R100 Part II contribution RESS/10 by IMMA

§	UN R100 series 02	Contribution IMMA
1.2	Part II: safety requirements with respect to the Rechargeable Energy Storage System (REESS), of road vehicles of categories M and N equipped with one or more traction motors operated by electric power and not permanently connected to the grid. Part II of this Regulation does not apply to REESS(s) whose primary use is to supply power for starting the engine and/or lighting and/or other vehicle auxiliaries systems.	<p><i>RESS IG Secretary: Has to be discussed at the end because a separate UN R for category L maybe a result.</i></p> <p>IMMA recommends to maintain IG RESS strategy to extend current Regulation with L-category vehicles.</p>

Figure 1
Generic description of test pulses

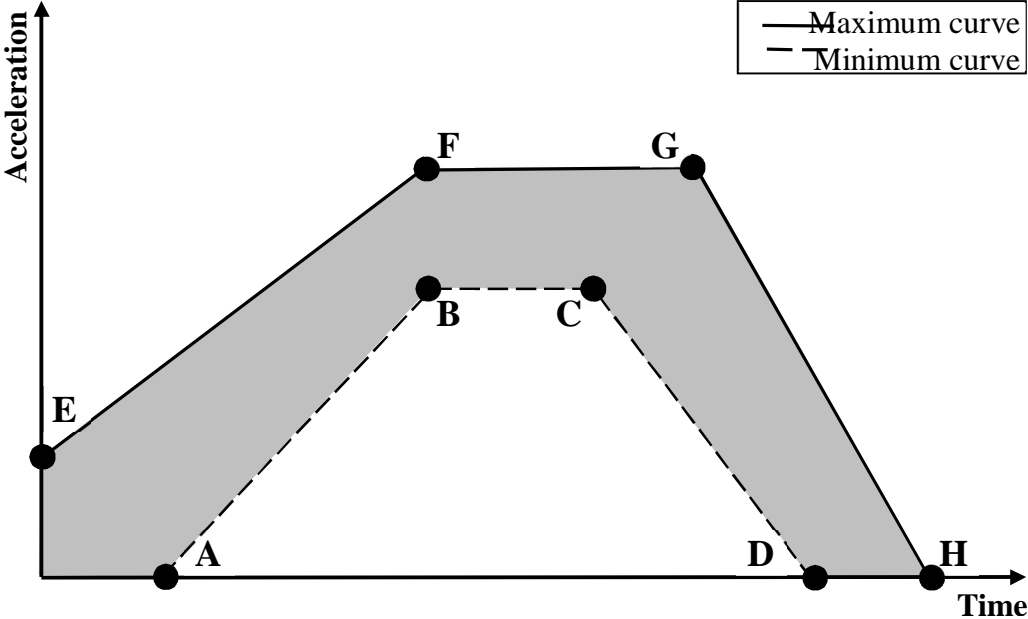
Annex 8 C Mechanical shock = Not applicable for L, see alternative test at J-K

Figure 7

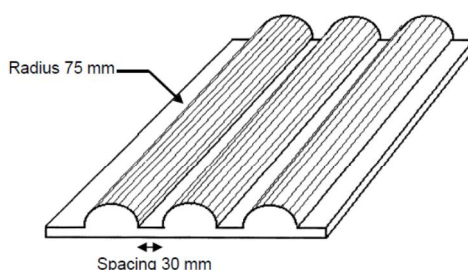
Annex 8 D Mechanical integrity, **not applicable for L-category**
